JUNCTION FLATS
4433-4441 42ND AVENUE SW, SEATTLE, WA

DESIGN RECOMMENDATION MEETING
DPD #3013912

AUGUST 29, 2013

STREET FACING UNITS - WALL SCREENING CONDITION

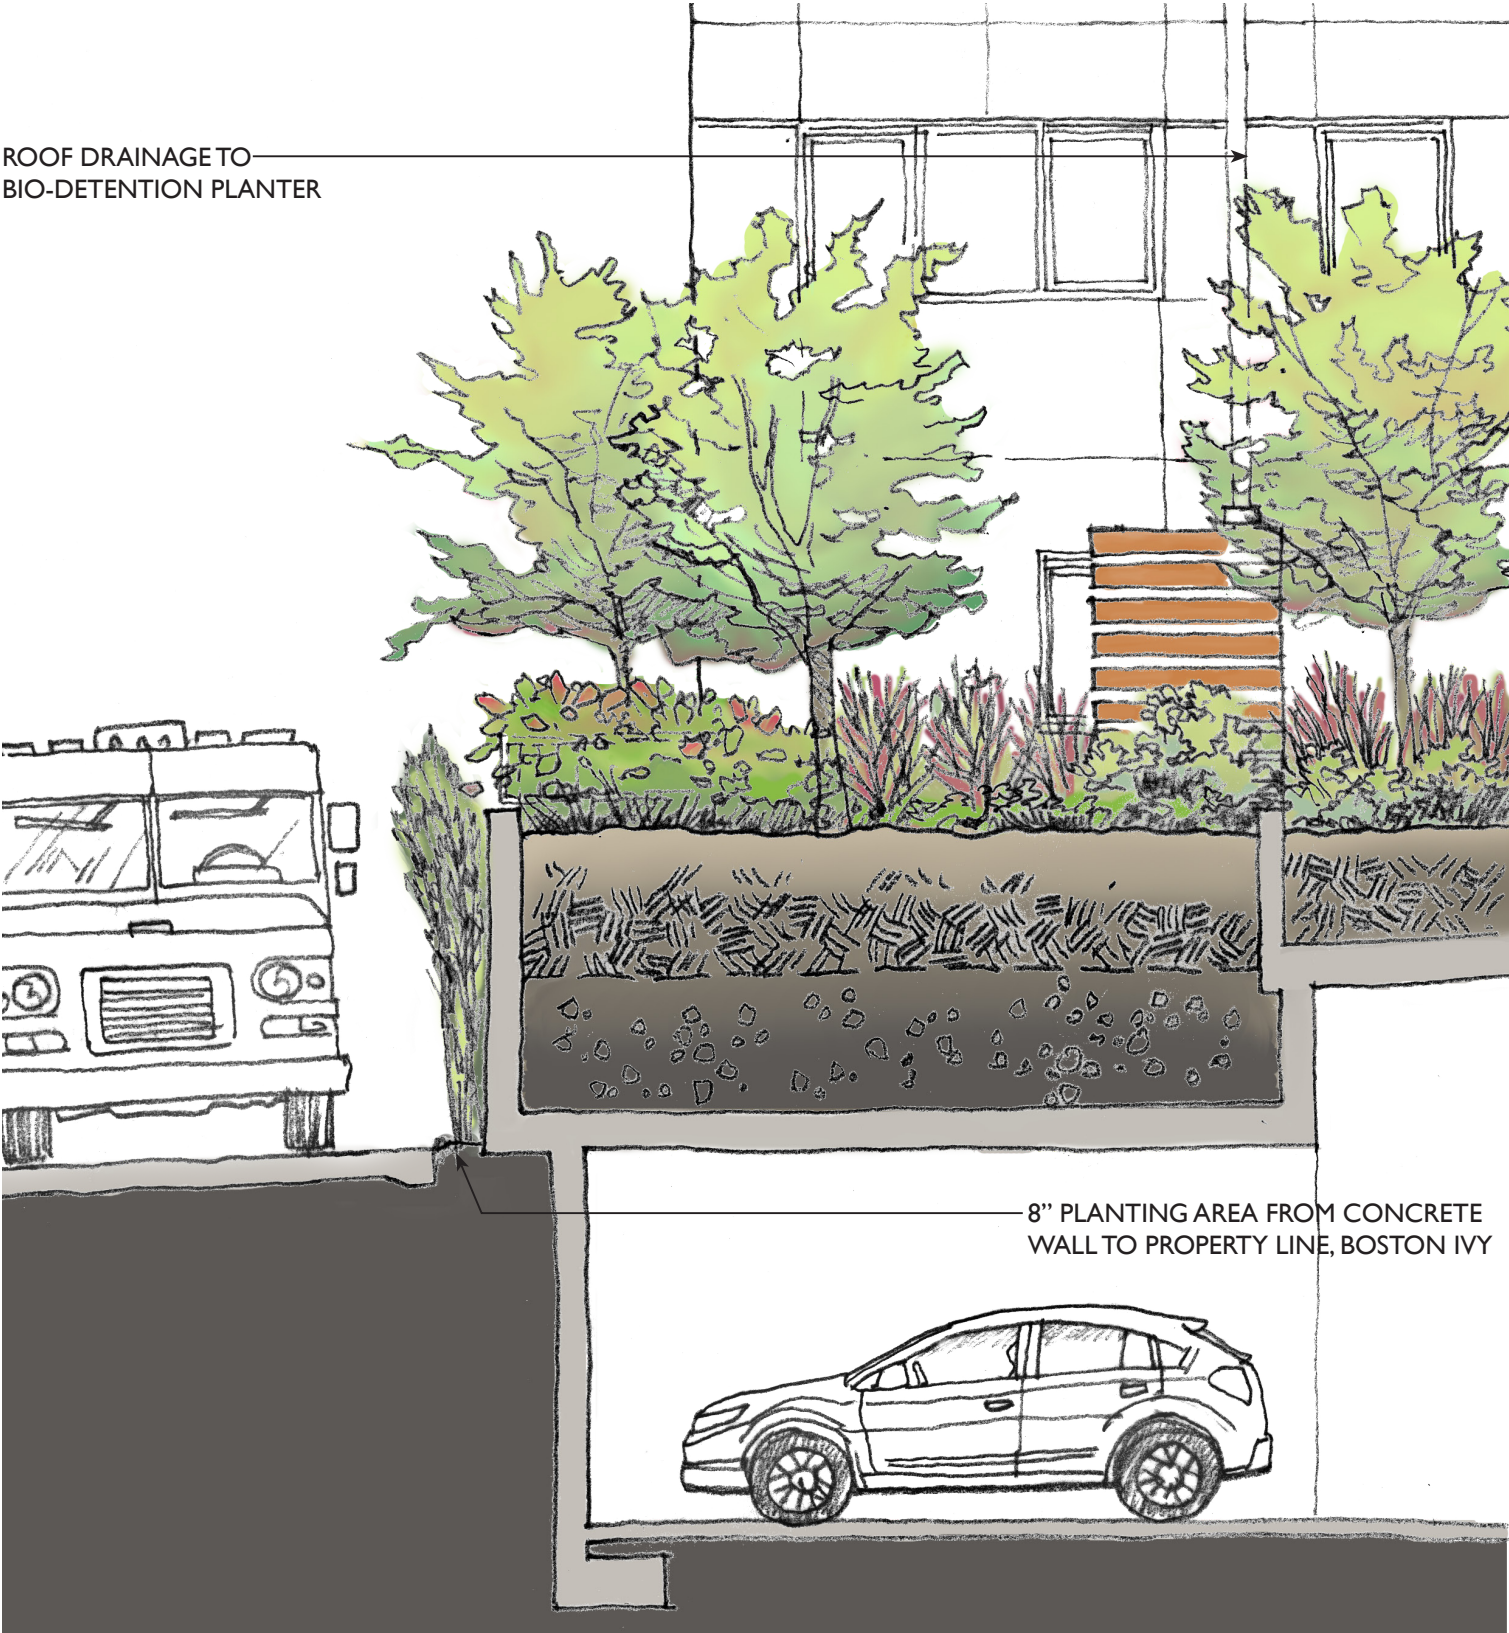
BOARD PRIORITY	RESPONSE
<i>(b) The Board discussed the merits between raised residential balconies and stoops with stairs for the first-floor residential units along the street-facing façade. The Board initially noted that a design inclusive of stoops would be more successful than raised balconies in creating a transition between the public sidewalks to the entrances. However, the Board recognized that, due to the horizontal distance from grade (approximately 7') created by the existing downward sloping condition from north to south, stoops would be problematic—would negatively affect available landscaping areas. Therefore, the Board stated it could support a design inclusive of raised balconies that enhance security and privacy to those units. The Board expects the applicant to continue to explore a stoop solution and provide renderings of this option at the Recommendation meeting. (C-3, D-12)</i>	<p>The merit of residential stoops along 42nd Ave SW was studied further but resulted in the same unfavorable conclusion as the Board's.</p> <ol style="list-style-type: none">1. Stoops degrade the integrity of a highly ordered and symmetrical design.2. The declining elevation of the sidewalk (max 7' rise) required long stair runs that were awkward in profile and consumed much of of the landscape buffer area.3. If the landscape area were to be preserved, the building footprint would have to be reduced by a minimum of 5' over the entire property frontage. The resulting loss in development potential is not acceptable.4. Stoops will compromise building security. <p>In this case (of an elevator served apartment building), we believe the drawbacks associated with individual residential stoops outweigh the potential benefits. Raised private patios overlooking the street remain the preferred option.</p>

<i>(c) The Board acknowledged that street-facing blank walls will need to be addressed. The Board expects to review details pertaining to any landscaping treatments (green screening) proposed to address this concern at the Recommendation meeting. (D-2, E-2)</i>	<p>Please see Landscape Plans.</p> <p>Of note is a 9' X 150' area behind the existing sidewalk that accommodates a lush multi-tiered landscape design screening the blank walls extant along 42nd Ave SW. A benefit of this extra planting area is the development of a double tree canopy framing the sidewalk. Screening bamboo and climbing ivy serves the same purpose at the alley.</p> <p>Please see Landscape Plans on pp. 30-36; Additional details provided on pp. 16-17</p>

COURTYARD OPEN SPACE & DRAINAGE TO BIO-DETENTION PLANTER

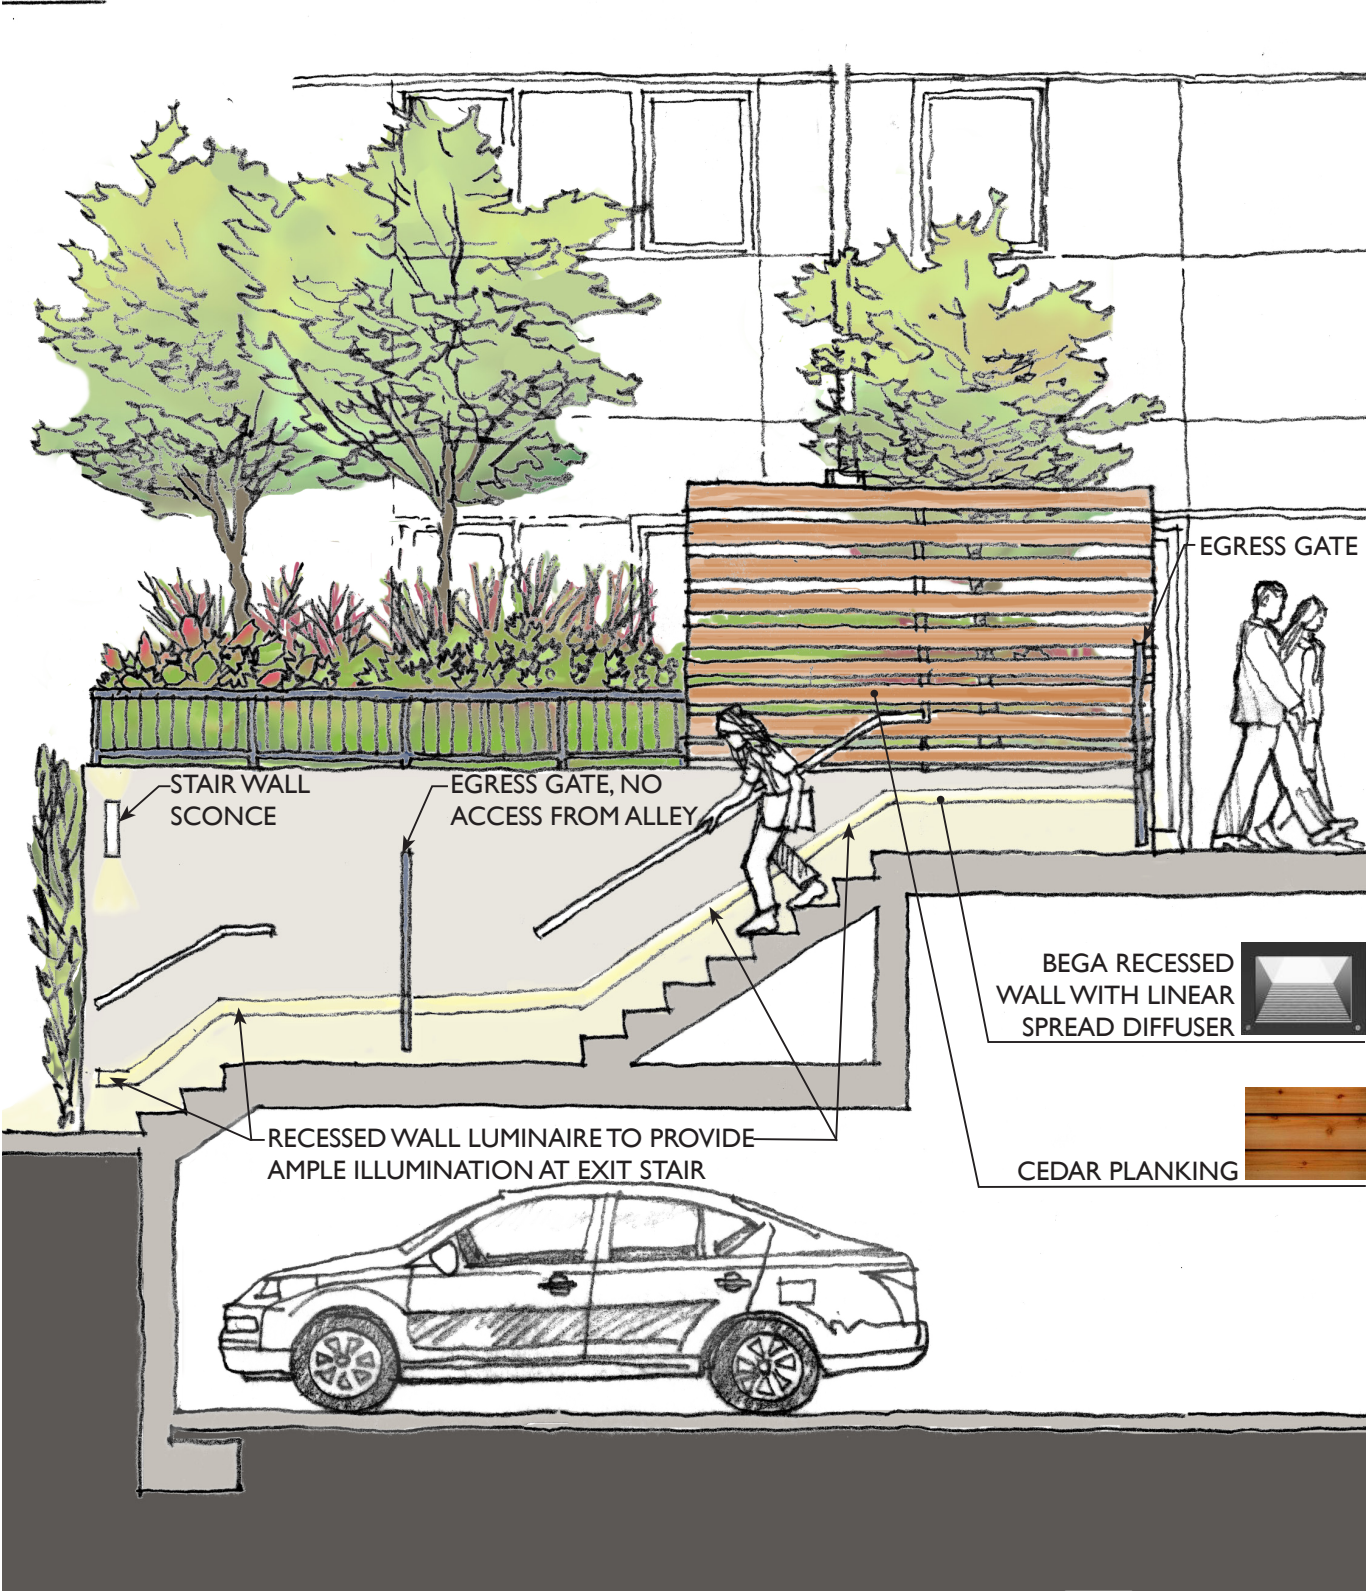
BOARD PRIORITY	RESPONSE
<i>(a) The Board felt the preferred design (Option 3) which illustrated a raised courtyard along the west alley side would create are more usable gathering area for the residents as opposed to the at-grade courtyard areas abutting the east street side which could become space that isn't usable by the residents. The Board agreed that a design which included courtyards situated on both the street and alley side is optimal, but voiced concern that the courtyard abutting the street not be long and narrow as illustrated in Options 1 and 2. (A-7)</i>	<p>A large courtyard is proposed at the west alley with the following functions:</p> <ol style="list-style-type: none">1. Both private and semi-private patios for apartments abutting the courtyard.2. Common landscaped courtyard3. Storm water detention (bio-retention planter)4. Exit passage <p>Private patios are defined by an arrangement of movable planters only. Hard privacy screens and patio fences will not be provided as it is anticipated that socially-oriented residents will self-select for these apartment locations. A communal area lies between the private patios and a large detention planter abutting the alley. The canopy provided by a minimum of 6 trees will further define the west edge of the communal space while providing a buffer to the alley further to the west.</p> <p>Please see Landscape Plans on pp. 30-36; Additional details provided on pp. 17-18</p>

<i>(b) At the Recommendation meeting, the Board stated that they expect to see elements (outdoor furniture, trees, landscaping, water features, etc.) that activate the proposed residential open spaces. (A-7)</i>	<p>Schematic space plans and furniture layouts have been developed for both the courtyard and roof amenity space.</p> <p>Please see Landscape Plans on pp. 30-36; Additional details provided on pp. 18-19</p>
<i>(c) An alternative location for the proposed rooftop deck area should be explored and presented at the Recommendation meeting. (A-7)</i>	<p>The proposed roof deck was relocated to the center portion of the roof, overlooking the west courtyard. Three distinct sitting areas are defined by planters, seating, and lighting, allowing multiple groups of people to utilize the space at the same time. Additionally, a generous dog run area is proposed for the east side of the amenity space. The roof deck is bounded on three sides by a green roof, intended to reduce stormwater runoff and buffer the roof edge.</p>
